Product Advisory

VR2AR receiver

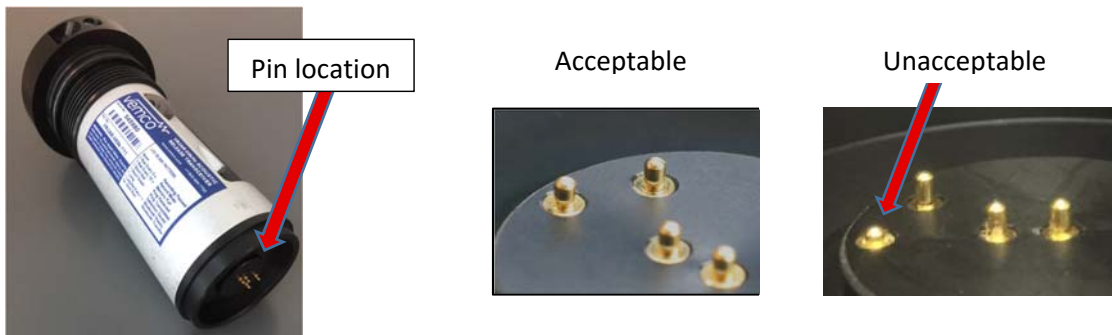
We have been recently made aware of a manufacturing issue causing the electrical compression pins to become seized in the VR2AR receiver. Seizing of these pins can affect the receiver's acoustic release function. While the VR2AR receiver includes redundant electrical compression pins, we are none the less advising customers to always test the release function on each VR2AR prior to every deployment.

- 1) Open receiver in a controlled, indoor environment and inspect pins (see picture below).
- 2) With clean hands, use your finger to press pins in lightly to ensure pins are compressing and fully releasing (see picture below).
- 3) When you have closed the unit for the final time before deployment (i.e. to connect or replace battery), perform a test release of the lug using VUE or your VR100-200 receiver for confirmation of proper connection.
- 4) It is important to perform the lug release test prior to any deployment.
- 5) If you need to re-open the receiver, complete the release test again.
- 6) If the pins do not compress and release fully (step 2 above) and/or the receiver does not release the lug (step 3), please contact the Vemco support team

We have addressed this issue in our manufacturing process and are confident that any new units will not be affected.
